SUNDANCE SUBDIVISION  
MASTER DEVELOPMENT  
PLAN #:  
DATE: 2-4-05

**MASTER DEVELOPMENT PLAN**

**SUNDANCE SUBDIVISION**  
**KB HOME**  
4800 FREDERICKSBURG ROAD  
SAN ANTONIO, TEXAS 78229

**City of San Antonio**  
**Development Services Department**  
**Master Development Plan**  
**APPLICATION**

## MASTER DEVELOPMENT PLAN

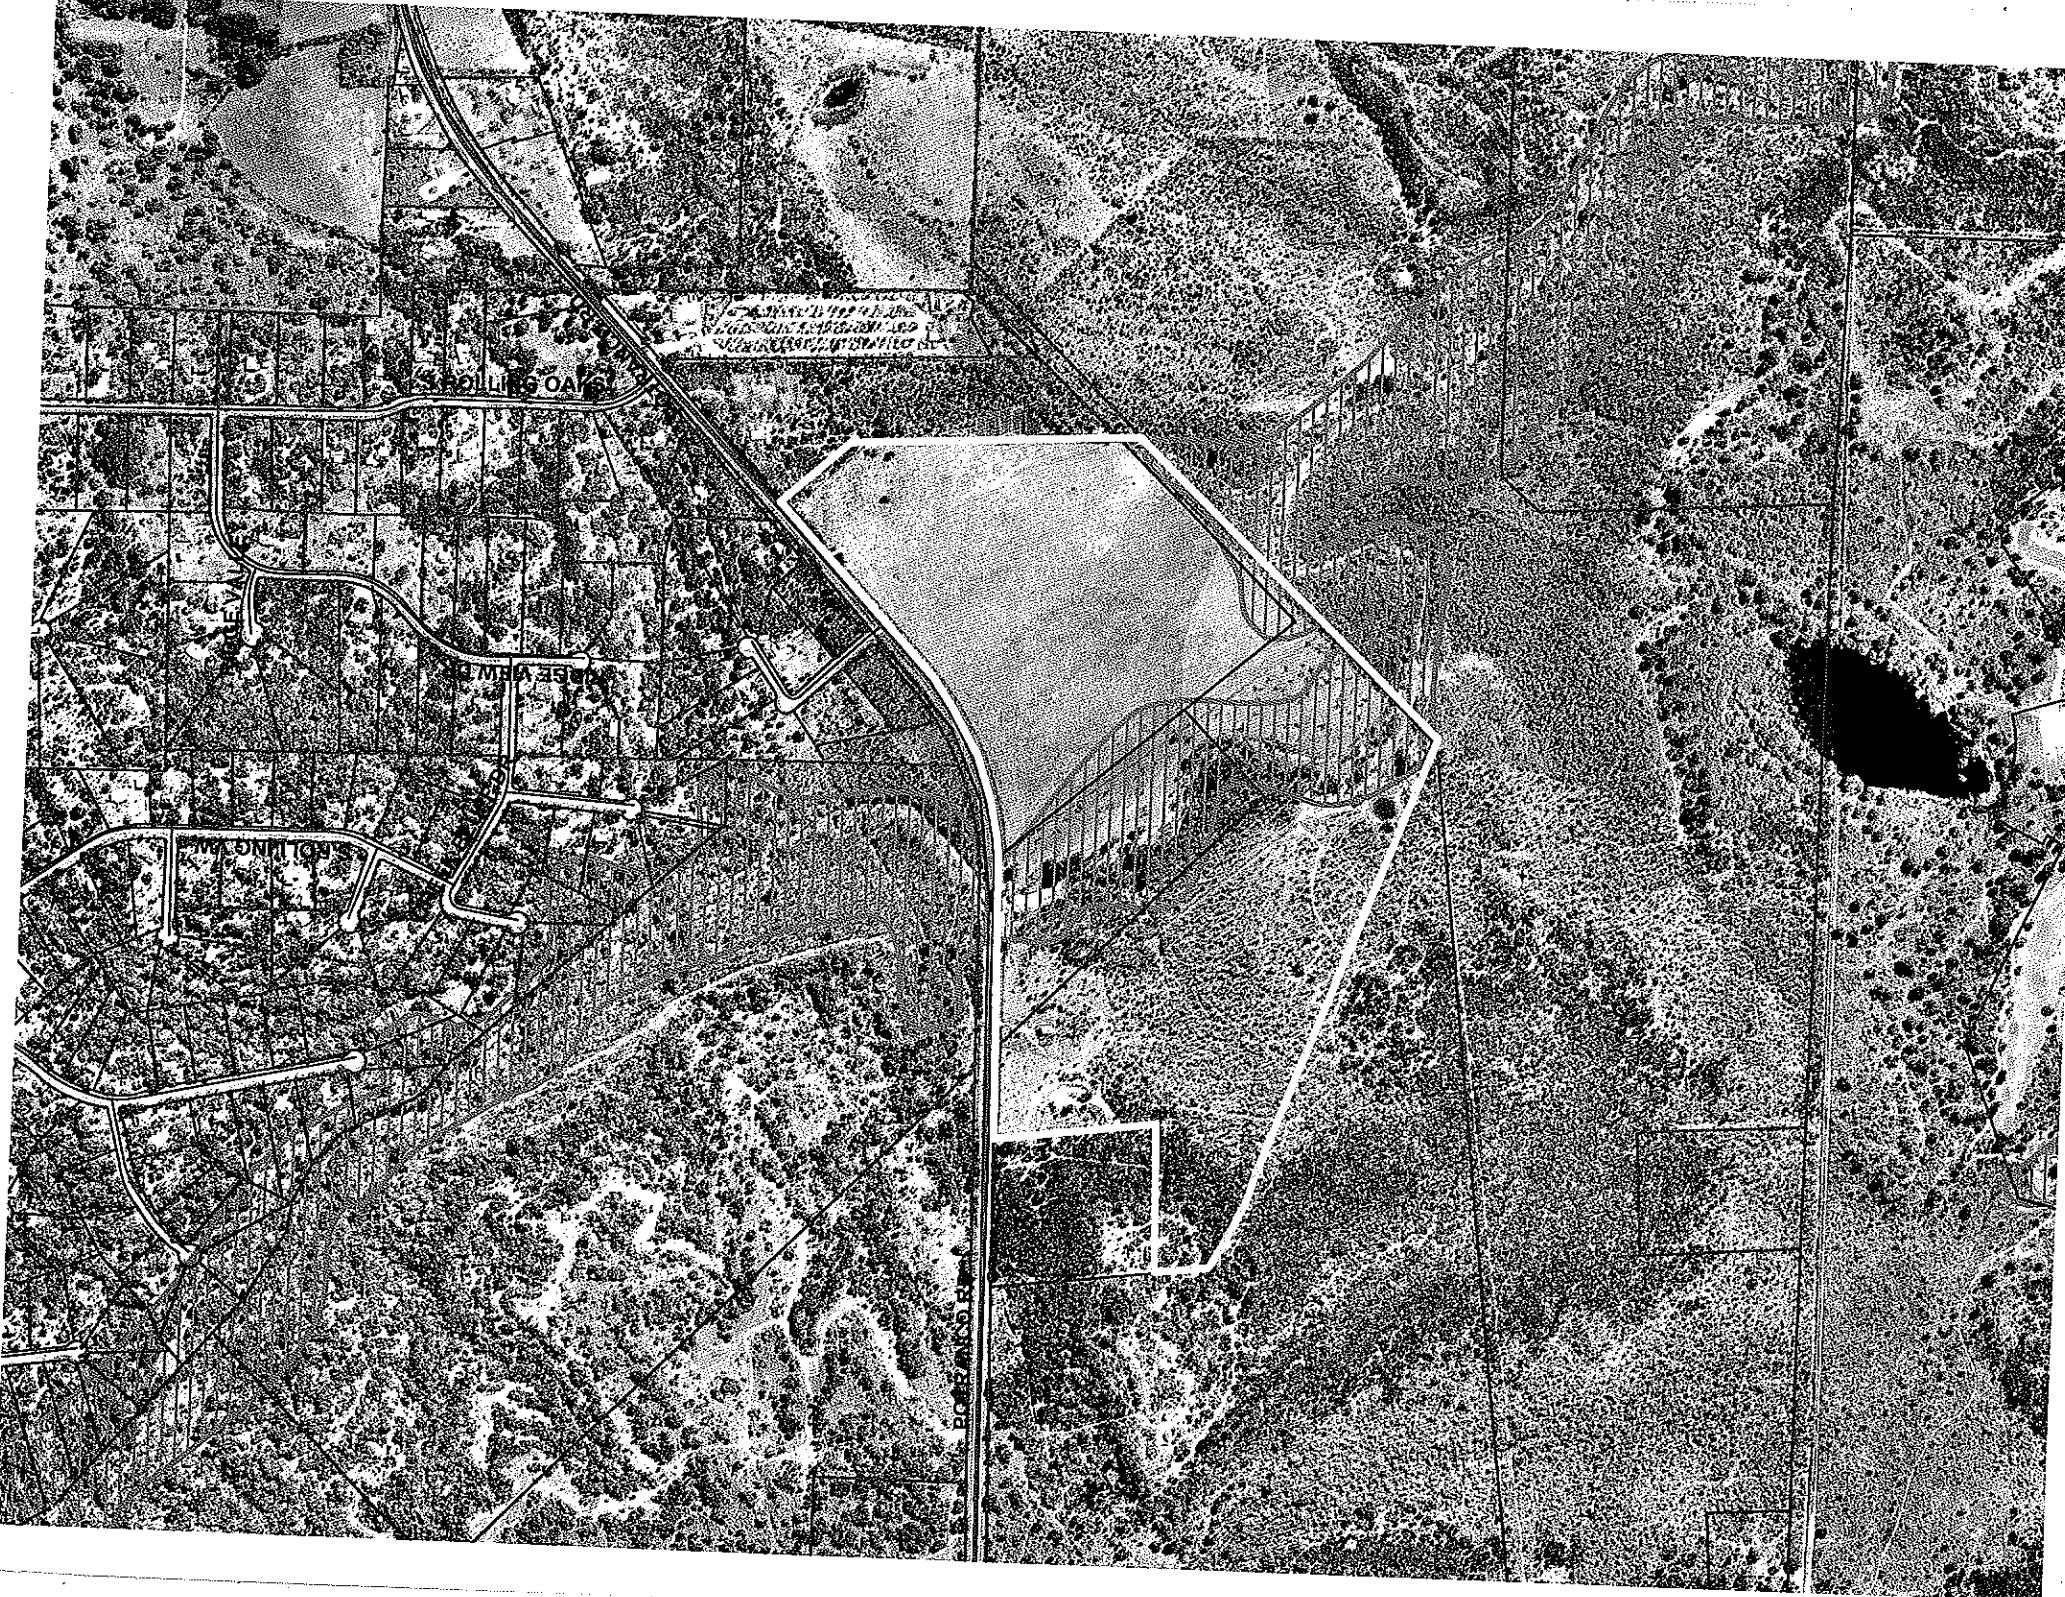
3) DELETE DEVELOPER/AGENT-ENGINEER <sup>LINE</sup> ~~IN~~ <sup>WITH DATES</sup> AND CHAIR PERSON, SECRETARY-DATE.

4) PUT NOTE ON PLANS: THE FLOOD PLAIN SHALL BE PLATTED WITH UNITS 4, 5, 6A AND 7 AT THE TIME OF PLATTING.

1. Require secondary access for both pods as per UDC 35- 506 (e) (7)✓
2. Label the perimeter of the project as "Project Limits"✓
3. Delete "Developer /Agent" Line and "Chair Person, Secretary" Line.✓
4. Place NOTE on plans: "The Flood Plain Shall be Platted with Units 4, 5, 6A, 7 at the time of platting".
5. Units 1, 2, 3, 4, 5 do not meet the connectivity ratio required by the UDC 35-506 (e) (1). ✓
6. Put dimensions at the entrances to the project. ✓
7. Local "B" streets may be required around all parks and amendities as required by TIA.
8. RED LINES will follow and will be at the Engineers pick-up box.

1. The above referenced MDP is approved with the following conditions:
  - a. Resolve the intersection issue between Streets E & B in Unit 1. UDC Section 35-506(f) states that "the centerline offset of intersections shall be at least 175 feet.
  - b. Add a note stating that all intersections shall comply with clear vision area requirements in accordance with UDC Section 35-506(d)(5).
  - c. It appears that the cul-de-sac in Unit 4 is greater than 500 feet in length, so it will require a turnaround right-of-way of 120 feet in diameter.
  - d. Show sidewalks on Potranco Road and connecting sidewalks at both entrances.
2. It should be understood that this is a general review of a conceptual plan and that ***all*** technical requirements of the Unified Development Code for Streets & Drainage shall be complied with.

- b. Add a note stating that all intersections shall comply with clear vision area requirements in accordance with UDC Section 35-506(d)(5).
    - c. It appears that the cul-de-sac in Unit 4 is greater than 500 feet in length, so it will require a turnaround right-of-way of 120 feet in diameter.

- d. Show sidewalks on Potranco Road and connecting sidewalks at both entrances.
  2. It should be understood that this is a general review of a conceptual plan and that *all* technical requirements of the Unified Development Code for Streets & Drainage shall be complied with.

- **Storm Water Engineering** has reviewed the Sundance (MDP) Master Development Plan submittal and comments are as follows: Be advised that the FEMA FIRM 100-year floodplain is inundating proposed lots on the Master Development Plan. This area will require a letter of Map Revision or Conditional Letter of Map Revision at the time of platting.

- 1.) SIDEWALKS SHALL BE INSTALLED IN THE PUBLIC R.O.W. PER THE CITY OF SAN ANTONIO UNIFIED DEVELOPMENT CODE REQUIREMENTS.
- 2.) ORIGIN OF STATE PLANE COORDINATES: N.A.D. 83/HARY 93 COORDINATES. ALL DISTANCES SHOWN ARE SCALED TO SURFACE USING COMBINATION SCALE FACTOR OF 0.999937.
- 3.) ADJACENT UNITS TO T&D R.O.W. WILL BE SUBMITTED TO T&D FOR REVIEW DURING THE PLATING STAGE.
- 4.) THE PROPOSED LAND USE WILL BE RESIDENTIAL.
- 5.) THE FLOOD PLAN SHALL BE PLATTED WITH UNIT 4, 5, 6A, 7 AT TIME OF PLATTING.

1. Per a meeting with Richard De La Cruz on March 14, 2005, the MPD has been revised to meets all required of the City of San Antonio.
2. The perimeter of the project has been labeled as "Project Limits."
3. Developer/Agent and Chair Person/Secretary signature blocks have been removed.
4. Floodplain note has been added as Note 5.
5. Units 1-5 connectivity index equal 1.24 and Units 6-7 connectivity index equals 1.21. This meets the UDC 35-506 (e) (1) requirement.
6. Dimension at the entrances have been provided.
7. Per a meeting with Richard De La Cruz on March 14, 2005, the MPD has been revised to meets all requirements for the TIA.

REMARKS: Robert, attached is the MDP with the sidewalk added and Potranco Road shown as per your request. If you have any questions or need any additional information let me know.
